Subject: Issuance of Amendment No. 9 to Facility Operating License  
NPF-9 - McGuire Nuclear Station, Unit 1

AMENDMENT TO FACILITY OPERATING LICENSE

SAFETY EVALUATION BY THE  
OFFICE OF NUCLEAR REACTOR REGULATION  
RELATED TO AMENDMENT NO. 9  
TO LICENSE NPF-9  
DUKE POWER COMPANY

AMENDMENT NO. 9 TO  
FACILITY OPERATING LICENSE NPF-9 - McGUIRE NUCLEAR STATION, UNIT NO. 1

FIGURE 3.2.3 RCS TOTAL FLOWRATE VERSUS  $R_1$  AND  $R_2$ —FOUR LOOPS IN OPERATION

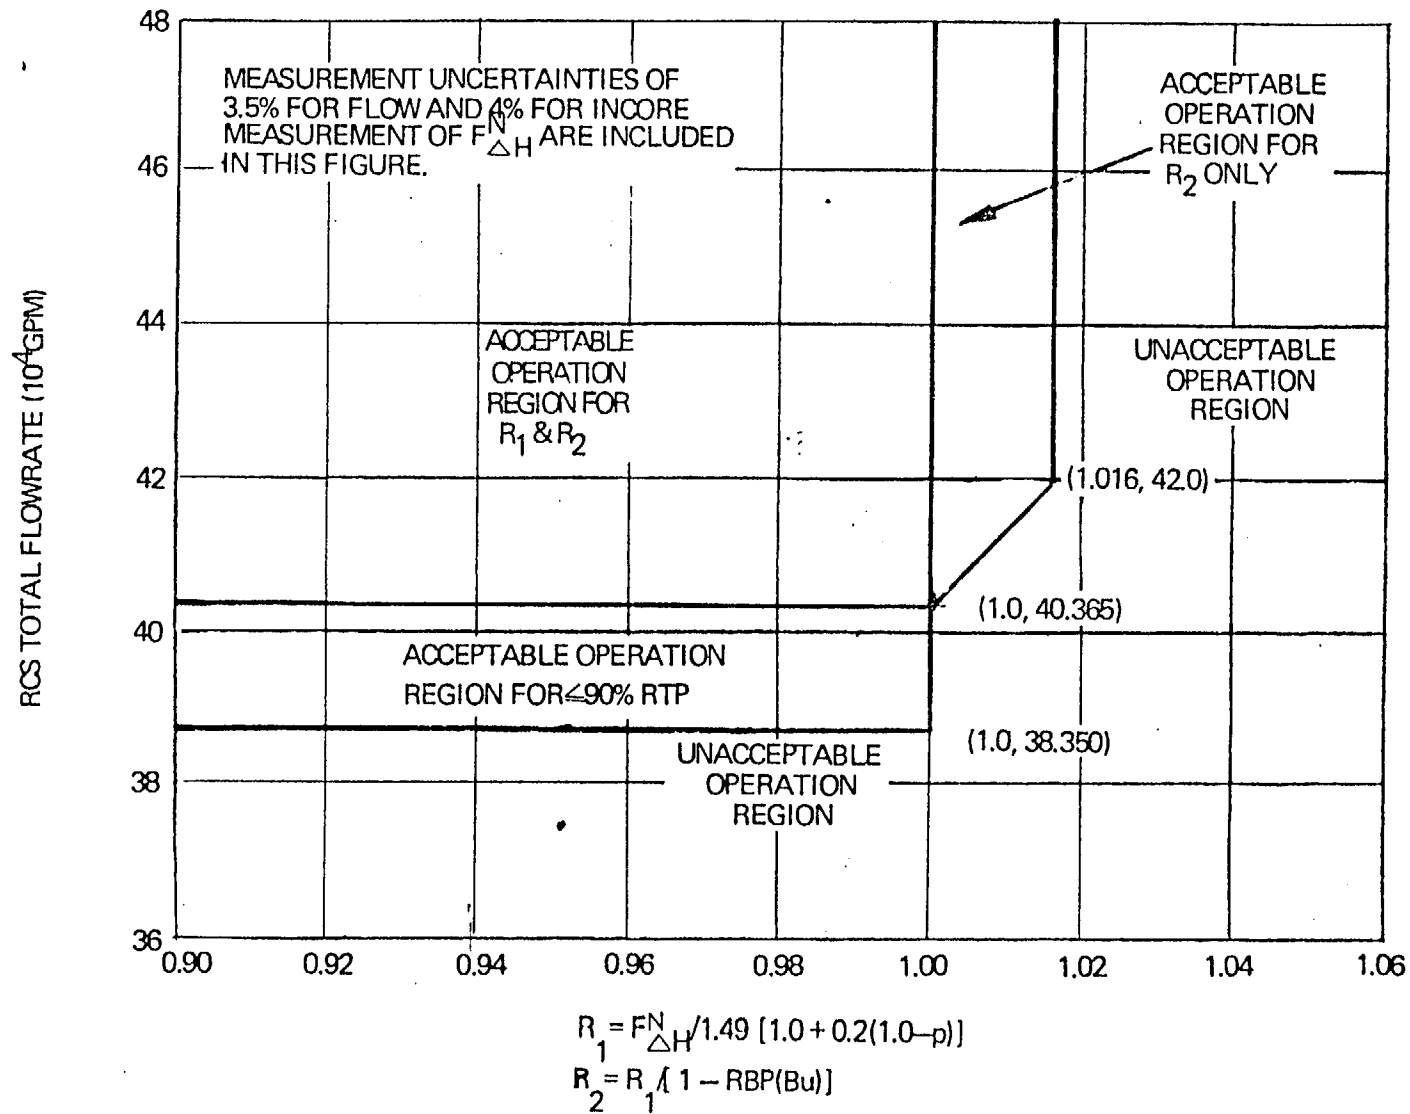
This amendment is in response to your letter dated November 11, 1981. This amendment revises the minimum reactor coolant system flow rate to permit an option for operation at a reduced flow rate (95%) in conjunction with a reduced power level (90%). The amendment is effective as of its date of issuance.

By letter dated November 11, 1981, the licensee requested a change to the McGuire Nuclear Station Unit 1 Technical Specifications, Appendix A, to License NPF-9, Item 3/4.2.3. The requested change relates to the minimum measured reactor coolant system flow rate. Based on preliminary measurements the licensee may be unable to achieve the thermal design flow limits defined in Item 3/4.2.3. The licensee requested that the Technical Specifications minimum reactor coolant system flow rate as a function of F be modified to permit an option for operation at a reduced flow rate (95% of the current value) in conjunction with a reduced power level (90% of the specification value). The reduced power level is specified to maintain the thermal margin at the full flow value which was the basis for the final design safety analysis.

Based on our evaluation we conclude that the proposed change to technical specification 3/4.2.3 is acceptable.
